January 18, 2013

Administrator
Land Quality Division
Wyoming Department of Environmental Quality
Third Floor West, Herschler Building
122 West 25th Street
Cheyenne WY 82002

Re: Comments on application for amendment to
Arch of Wyoming Saddleback Hills underground
coal-mining Permit 730-T2

Figure 2.9 Generalized Mining Plan, Elk Mountain and Saddleback Hills Mines.

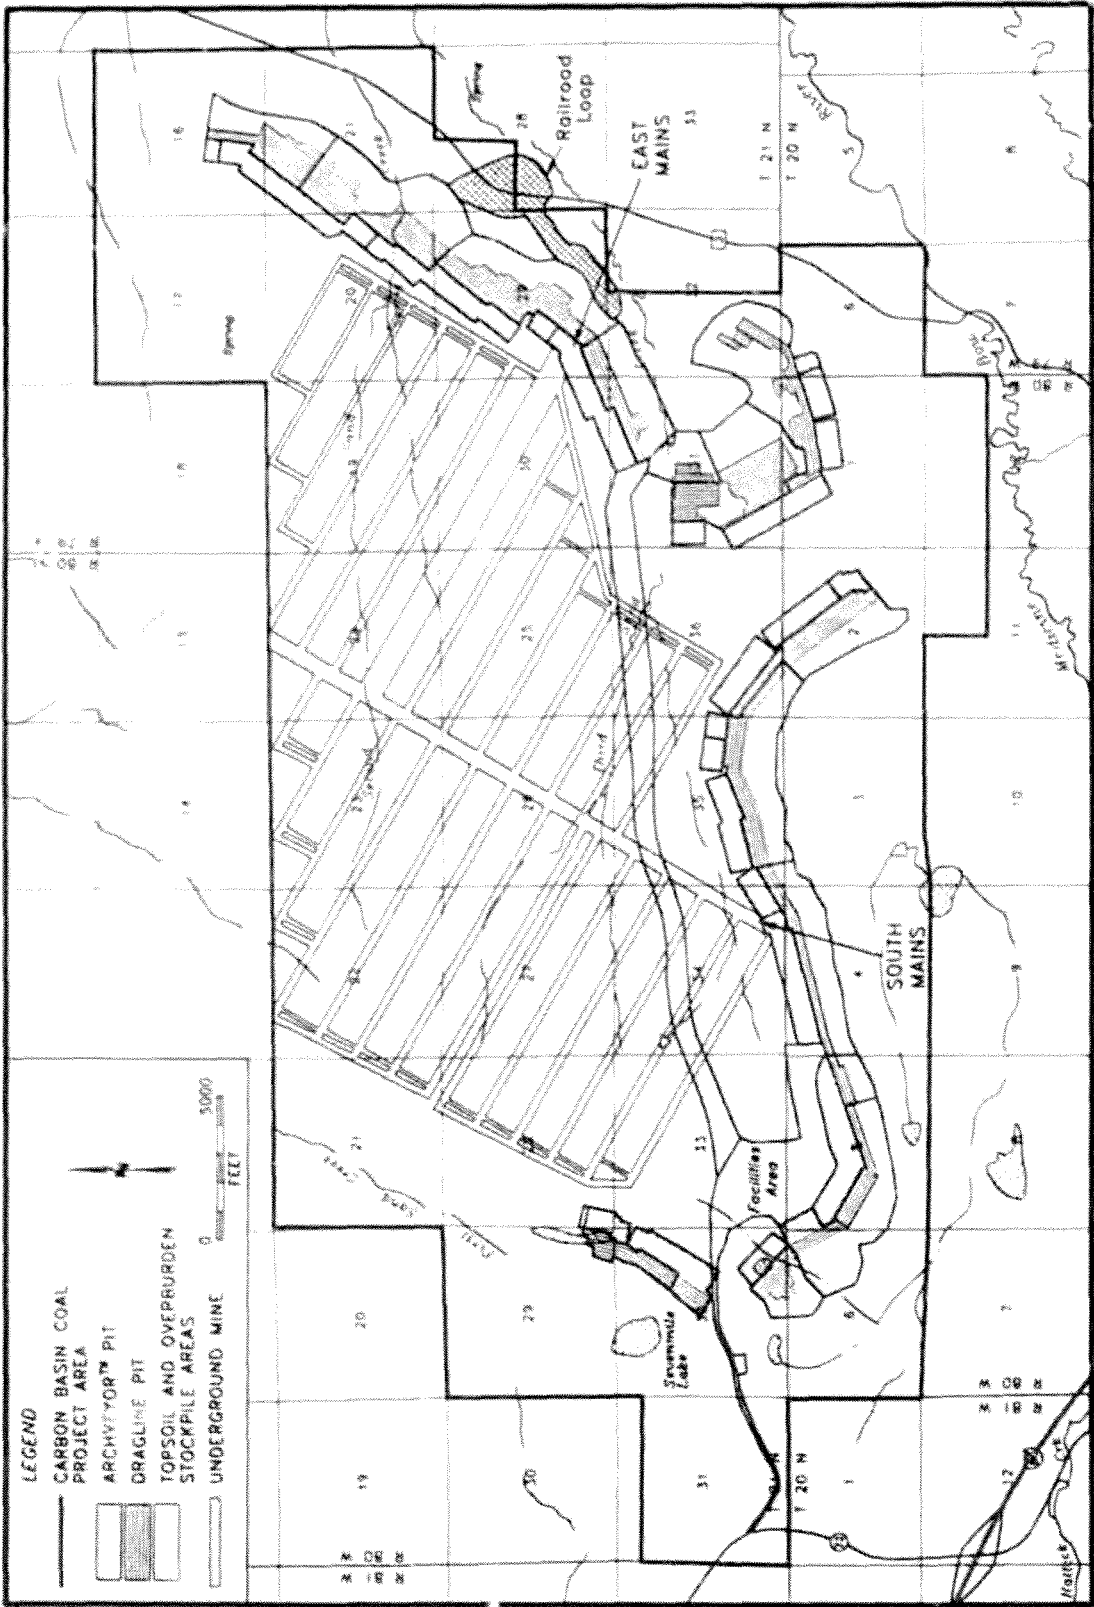
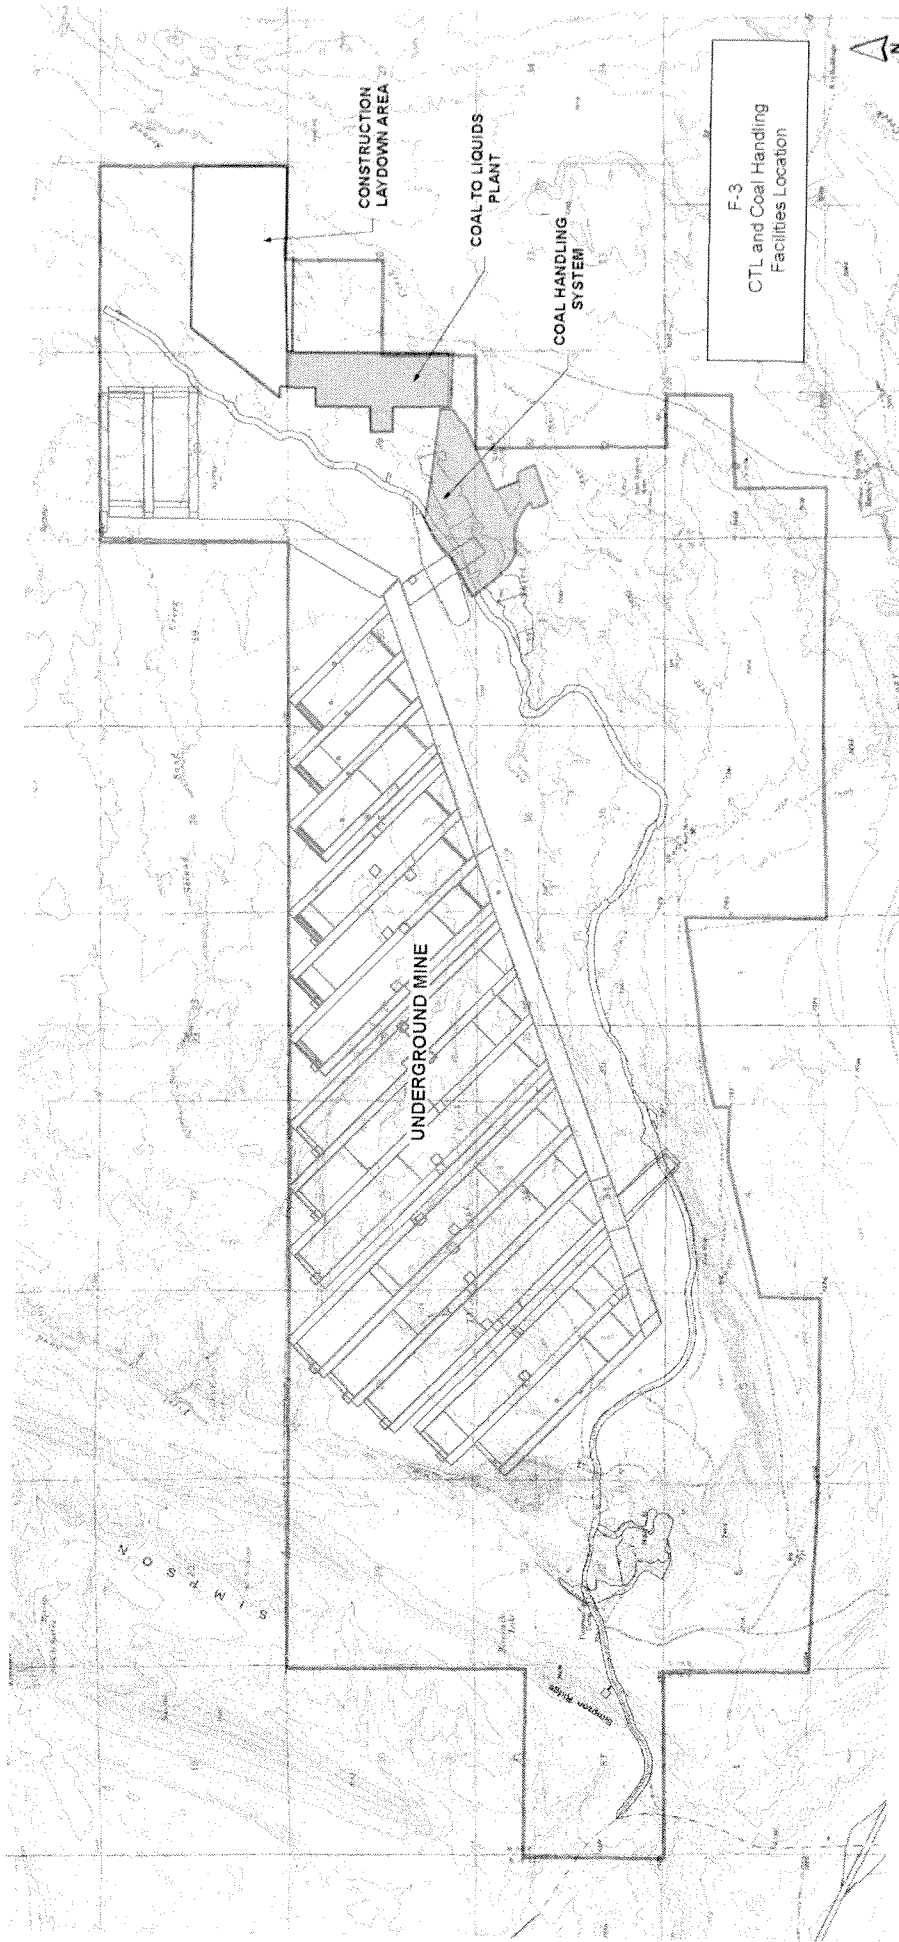
As background, 'Arch of Wyoming, LLC' (a subsidiary of Arch Coal, Inc. of St. Louis) was specifically identified in the Draft (July 1998, DES-98-32) and 'Final Carbon Basin Coal Project Environmental Impact Statement, Carbon County, Wyoming' (January 1999, FES-98-42) as the coalmine developer for the map area shown in Figure 2.9 (Final EIS, p. 2-2; copy attached). Fourteen years ago, when that EIS was released, the project involved only a commercial coal-mining operation that planned sale of coal to unspecified, off-site buyers. The mining plan of that time involved underground procedures, accessing minable coal that is 250 to more than 800 ft below ground surface (1998 Draft EIS, p. 2-11) along with extensive, adjacent, open-pit strip mining. Elongated, open pits would be required to access coal located as much as 250 feet below the surface (ibid, p. 2-11). Existence of initial, surface-based strip mining (the partially completed 'Elk Mountain Mine') was correctly recognized as essential to subsequent development of the entire, much more extensive, underground mining process (the still-planned 'Saddleback Hills Mine'):

A preceding paragraph mentioned existence of MBFP's mine map as presented (p. 3 of Appendix F; see attachment) in the 2007 project application to ISC. Such a document, which accompanied sworn testimony used by members of ISC as a fundamental component in its decision-making process, must be taken seriously. That map differs in three crucially important ways from Arch of Wyoming's mine plan as considered in BLM's now-expired, Final EIS: (1) underground mining is no longer planned in sections 21–24 of T. 21 N., R. 80 W. or in section 19 of T. 21 N., R. 79 W.; (2) all open-pit strip mining is removed from project planning; and (3) the northeastern buffer area (i.e., secs. 16–17 of T. 21 N., R. 79 W.) is eliminated from use in the project. No explanations accompany those three elements of project reductions within MBFP's permit application or hearing testimony. Neither were those reductions subsequently questioned by ISC (or DEQ in general) prior to issuance of its Order of January 16, 2008 granting authorization for MBFP to commence construction of the CTL facilities. The amount of coal authorized to date by ISC for use in the MBFP project is limited to source areas exhibited in its application's mine plan (in Appendix F).

Mine reductions '1' and '2' as cited in the preceding paragraph raise signal concerns about the adequacy of coal to support this CTL project through its originally proposed lifespan. First, note that in BLM's EIS of the late '90s (see DES-98-32, Table 2.12, p. 2-37), recoverable coal from planned *surface* sources totals c. 31.1 million tons and: "Of the 197.1 million tons of underground-minable coal, 88.02 million tons (45%) would be recovered" (DES-98-32, p. 2-28). Secondly, following MBFP's unexplained rejection of strip mines combined with reduction (by approximately 50%) of area dedicated to *underground* mining, only about 44 million tons of coal has been allocated to this project's use. Very conservatively, coal needs for conversion to gasoline at the average output rate of 11,000 barrels per day across 30 years would demand in excess of 60 million tons.
